07-002

Development Services Master Development

TO: Jose Ruiz Quintaro **DATE:** March 14, 2007 Address: 10325 Bandera Road San Antonio, TX 78269 FROM: Larry Odis, Case Manager COPIES TO: File **SUBJECT:** PUD# 07-002 Name: Presidio Heights The plat or plan referenced above was heard by the ✓ Planning Commission ☐ Director of Development Services on the date shown. The following action was taken: **⊠**APPROVED with conditions □ DISAPPROVED A plat will not be recorded pending site improvements, the required guarantee is posted or payment of impact fees are paid (or filed). Approved with the following Conditions:

TYPICAL LOCAL "A" STREET CROSS-SECTION

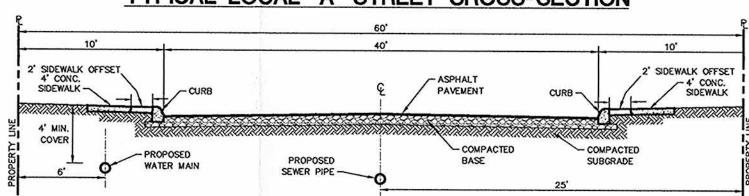
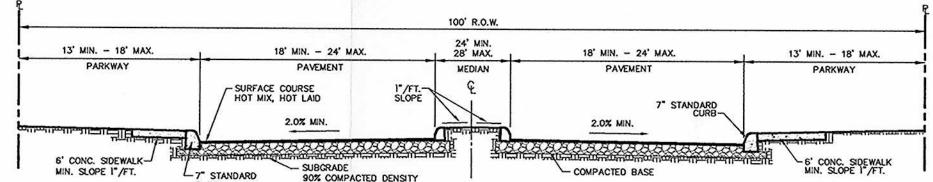
DSD - Traffic Impact Analysis & Streets indicate that under the UDC listed below are some of the requirements and onsite improvements that are necessary and shall be provided

- All Roadways shall conform to UDC 35-506(C)(1), Table 506-1: Functional Classification System Description.
- All access driveways shall comply with UDC 35-506(r) Access and Driveways.
- All access driveways shall provide clear sight distance on all existing and proposed roadways in order to provide adequate obstruction free viewing distances for approaching traffic. All signage, landscaping, and improvements shall be selected and located so as to not block these clear sight distances areas.
- The developer shall be responsible for providing right-turn deceleration lanes with storage lengths and bay taper in all the driveway access point approved by TXDOT as it relates to the submitted TIA traffic counts, Unified Development Code (UDC) 35-502 (a)(7), subsection C.
- Note: Texas Department of Transportation (TXDOT) will determine access point along N.W. Military.
